# Access Compliance Report

## Public Rights-of-Way

Intersection ID: 53404	Main Street: MAIN_ST	Cross Street: MORGAN_PARK_DR	Location: NE
ADA ID: 9284A95B488F	Ramp Type: PerpDiag	Initial Pass/Fail: Fail	Overall Compliance: No
Severity Score: 48.75			
Codes/Mitigation Info/Possible Solution		Field Measurements/Component Compliance

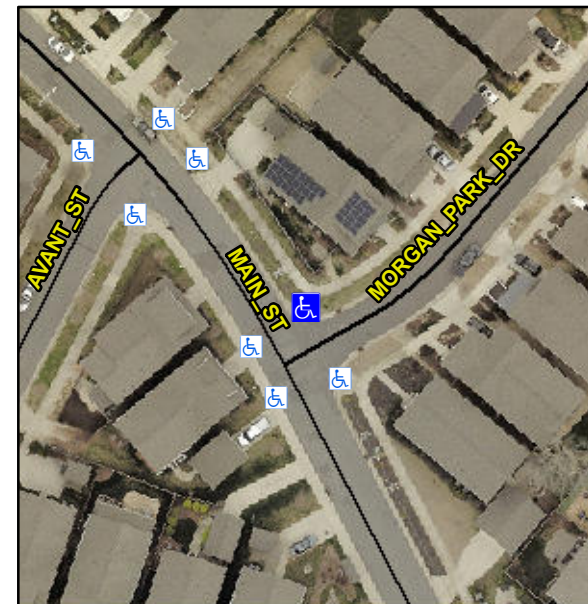
**Not Found, R304.5.1, R304.2.2, R304.5.3**

Compliance	Description	Data	Compliance	Description	Data
N/A	Ramp Length (in)	123.0	No	Ramp Slope (%)	10.2
No	Ramp Width (in)	30.0	No	Ramp XSlope (%)	3.2
N/A	Flare Type LT	N/A	N/A	Flare Type RT	N/A
N/A	Flare Slope LT (%)	N/A	N/A	Flare Slope RT (%)	N/A
N/A	Flare Traversable LT?	N/A	N/A	Flare Traversable RT?	N/A
N/A	Landing Length (in)	N/A	N/A	DWS Provided?	N/A
N/A	Landing Width (in)	N/A	N/A	DWS Contrast?	N/A
N/A	Landing Slope (%)	N/A	N/A	DWS Length (in)	N/A
N/A	Landing X Slope (%)	N/A	N/A	DWS Full Width?	N/A
N/A	Landing Curb? (Y/N)	N/A	N/A	DWS Offset (in)	N/A
N/A	Shared Landing?	N/A			
N/A	Gutter Ponding?	N/A	N/A	Gutter Slope (%)	N/A
N/A	Gutter Lip Ht (in)	N/A	N/A	Gutter X Slope (%)	N/A
N/A	Painted X Walk1?	No	N/A	Painted X Walk2?	No
	X Walk 1 Direction	To SW		X Walk 2 Direction	To SE
N/A	X Walk 1 Width (in)	N/A	N/A	X Walk 2 Width (in)	N/A
	X Walk 1 Slope (%)	7.0		X Walk 2 Slope (%)	1.1
	X Walk 1 X Slope (%)	0.7		X Walk 2 X Slope (%)	2.3

**Remove & Replace Curb Ramp With Two New Directional Ramps or Equivalent.**
